Summerlin West Village 25

Technical Drainage Study for Scurry Bend Drive
Sunset Run Drive to Lake Mead Boulevard

Supplement to Addendum #2

CITY OF LAS VEGAS			DATE:	
INTER-OFFICE MEMORANDUM			October 26, 2022	
TO: Land Development Services Department of Building & Safety			FROM: Albert Sung, P.E. Flood Control Project Engineer Department of Public Works	
SUBJECT:		Drainage Study for:	COPIES TO:	
Summerlin West V25 - Scurry Bend Drive Improvements (from Sunset Run Dr. to Lake Mead Blvd.) – Update #1			Atkins	
Cross Streets:	Scurry Bend Drive. & Lake Mead Boulevard		Howard Hughes Company, LLC	
File Number:	F:\Depot\DSMemos\DS5427D.doc		Bart Anderson, P.E., DevCo	
Parcel Number:	137-15-801-002 & more			
Zoning Action:	N/A			
FEMA Flood Zone	YES	NO	X	
Proposed Storm Drain	YES	X	NO

SUMMERLIN WEST VILLAGE 25
SCURRY BEND DRIVE (STREET N)
SUNSET RUN DRIVE TO LAKE MEAD BOULEVARD
STORM DRAIN LATERAL PROFILES

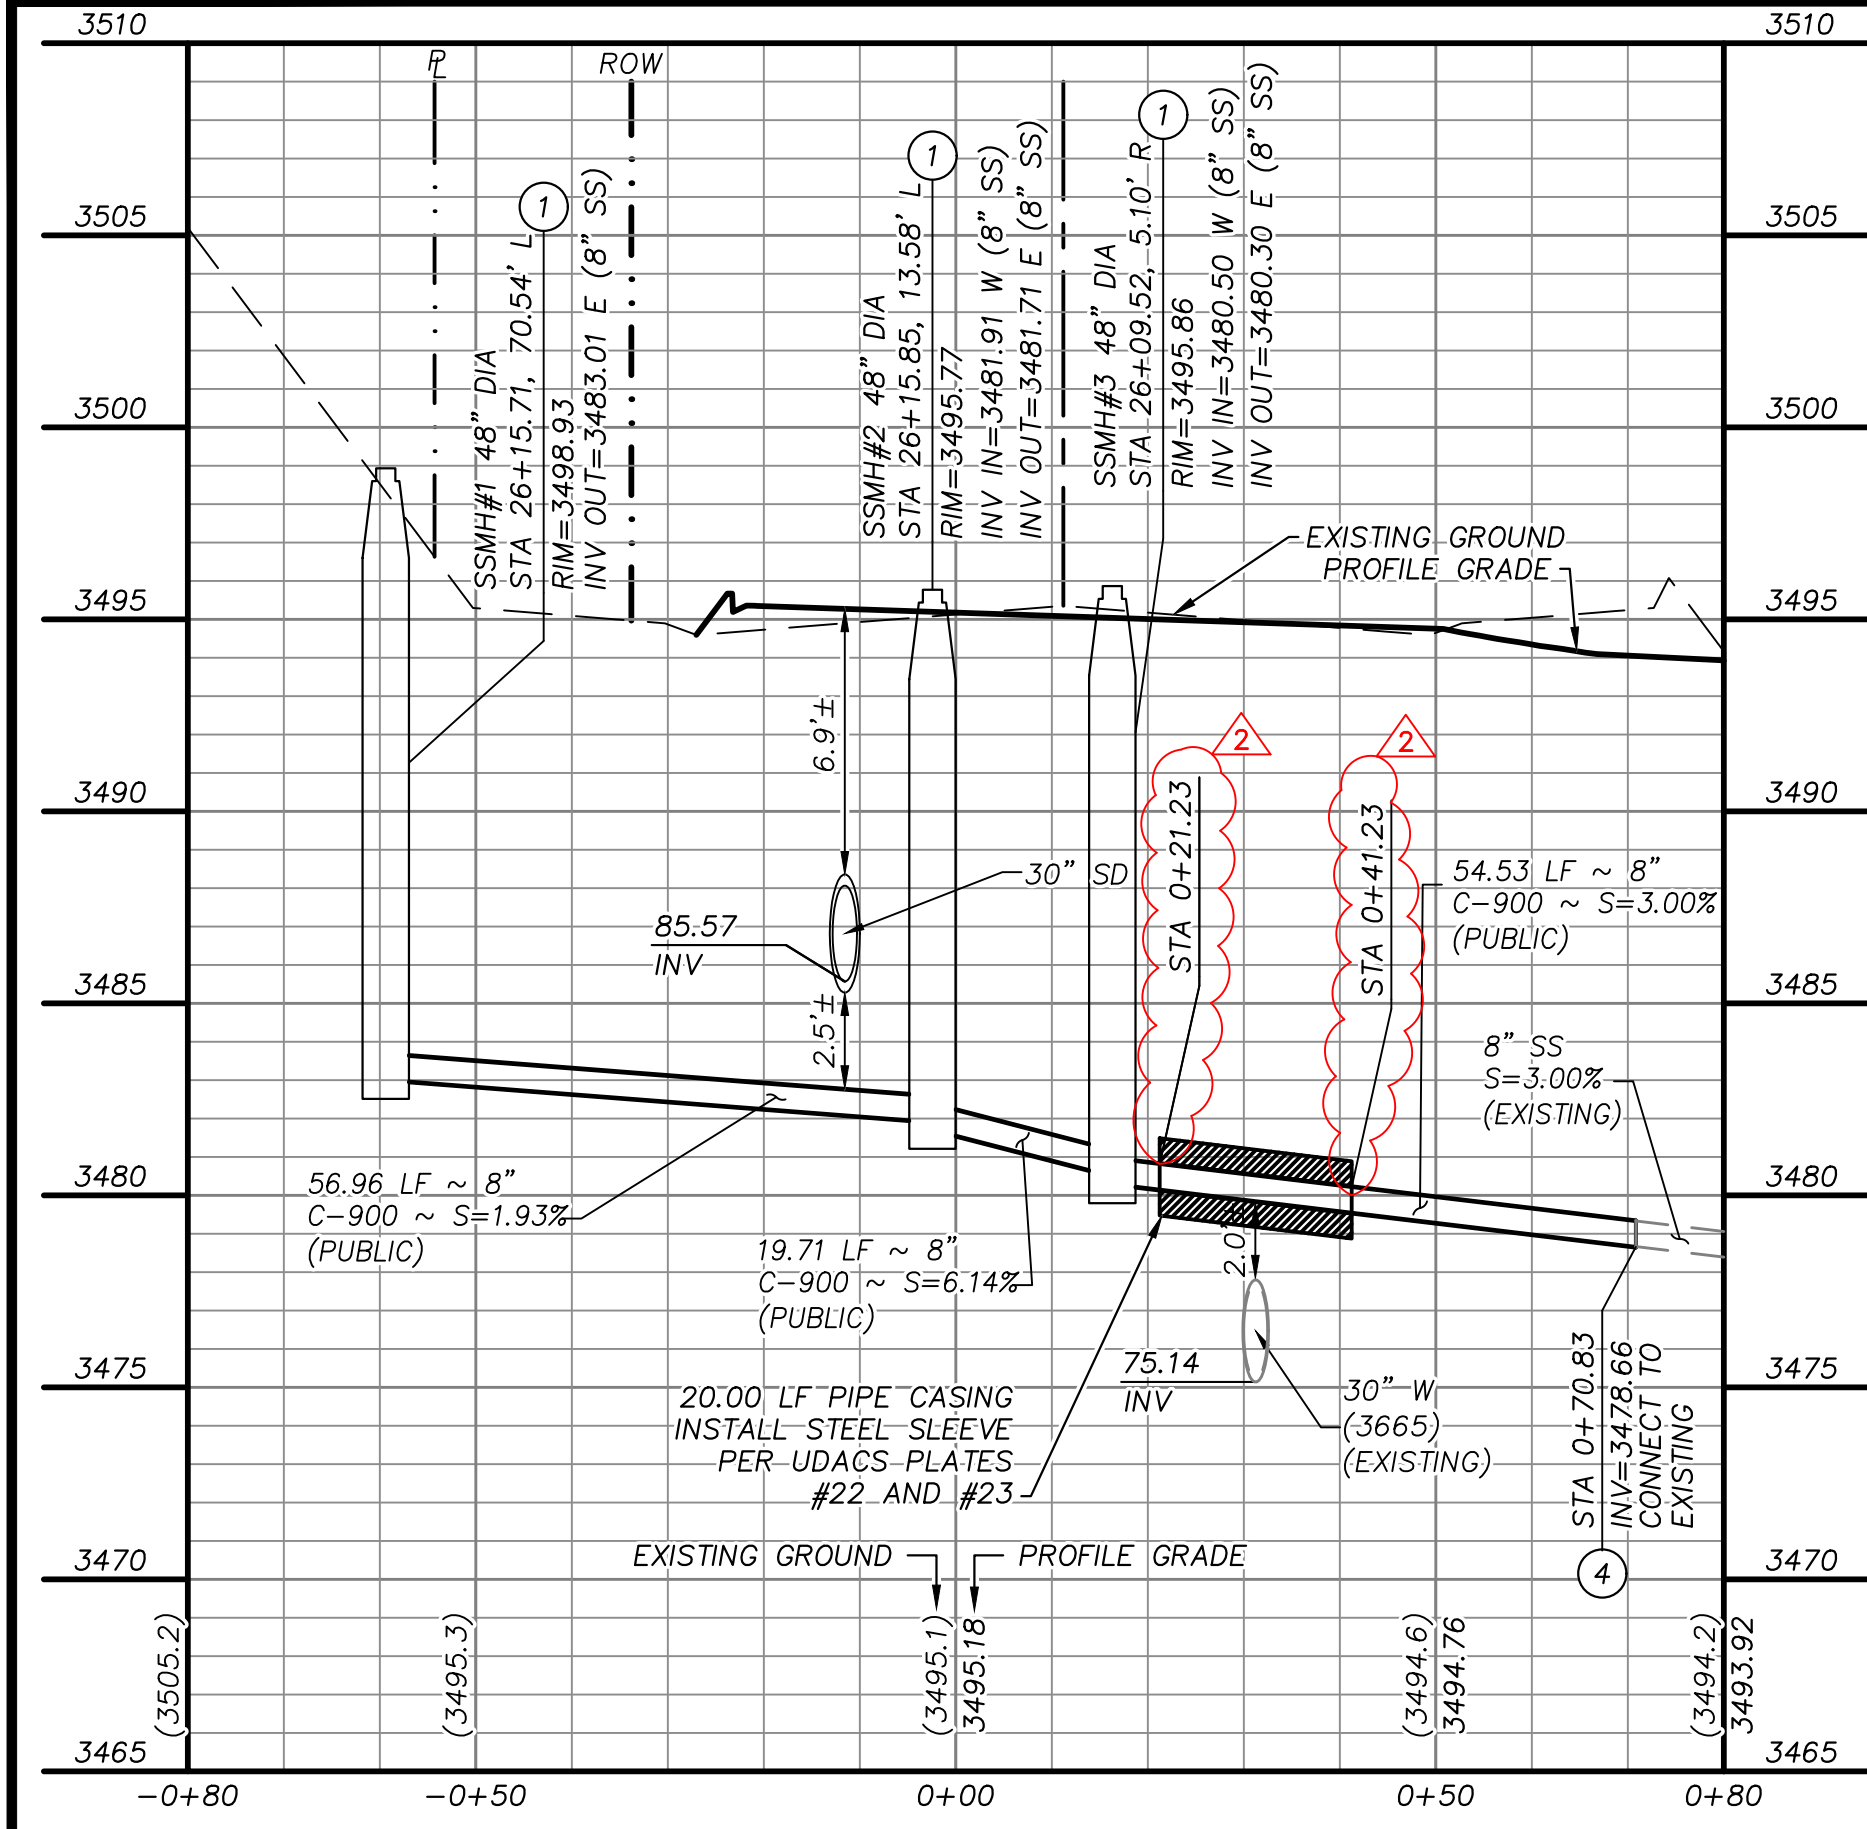
1. The plans in the last submittal appear to be not revised at all:

For example: Per the *Table of Revision* in Page 4 of the *Update Study*, the “INV IN” of SDMH #3 has been updated from 3491.93 to 3494.41 while the “INV OUT” has been updated from 3491.73 to 3494.21.

However, per **Storm Drain Lateral Profiles (Sheet 24/49)**, see **Storm Drain Lateral 2 (B/24)**, both the “INV IN” and “INV OUT” showed the previous values still.

Double check the plans for other impacted SDMHs and SDDIs whether they have been revised per the revision table in the *Update Study*.

This supplemental document aids to clarify and document the changes made in the hydraulic analysis originating from the revisions made to the plans for the storm drain system in Addendum #2. The revisions made affects only the hydraulics of storm drainage system. The revisions were minimal, and it did not affect the system capacity adversely. The invert levels and pipe lengths were revised for some segments and have been documented in the table below. The WSPG-W model has been updated and rerun to reflect the changes.

A previous version of this supplement was submitted in October 2022 with the columns below not described clearly. The updated value is the value that was updated in the WSPG-W model because the previously approved WSPG-W model did not match the Revision submittal from the improvement plans, so updated value refers only to the WSPG-W model. The plans did not change. The previous value column describes the original WSPG-W value. Neither the plans nor the WSPG-W model have been revised since the October 2022 submittal, only this clarification.

Item No.	Location	Parameter	Updated value, ft	Previous value, ft
1	SDMH#3	INV IN	3491.93	3494.41
2	SDMH#3	INV OUT	3491.73	3494.21
3	SDMH#3 to SDMH#4	LF	167.13	168.1
4	SDMH#4 to SDMH#5	LF	131.23	131.41
5	SDHM#7 to SDMH#6	LF	404.90	411.67
6	SDMH#7	INV IN	3500.02	3500.22
7	SDDI#2	INV OUT	3493.35	3494.6
8	SDMH#3	INV IN	3491.93	3494.41
9	SDMH#3	INV OUT	3491.73	3494.21
10	SDDI#3	INV OUT	3494.18	3495.18
11	SDDI#2 to SDMH#3	LF	14.34	11
12	SDDI#3 to SDHM#3	LF	68.76	66.77
13	SDDI#4 to SDMH#5	LF	NA	Added
14	SDMH#7	INV OUT	3500.20	3500.02
15	SDDI#6 to SDMH#7	LF	68.14	68.15
16	SDDI#5 to SDHM#7	LF	16.62	16.87
